AMENDMENTS TO THE DRAWINGS

The attached replacement sheet of drawings includes the following changes to Figure 1:

Fig. 1

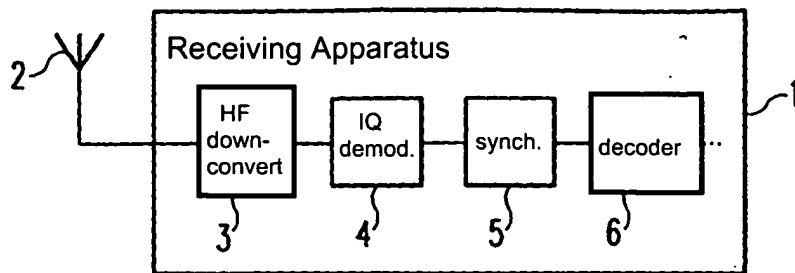
In Figure 1, reference element 1, please add the label —RECEIVING APPARATUS—as indicated.

In Figure 1, reference element 3, please add the label —HF DOWNCONVERT—as indicated.

In Figure 1, reference element 4, please add the label —IQ DEMOD.—as indicated.

In Figure 1, reference element 5, please add the label —SYNCH.—as indicated.

In Figure 1, reference element 6, please add the label —DECODER—as indicated.
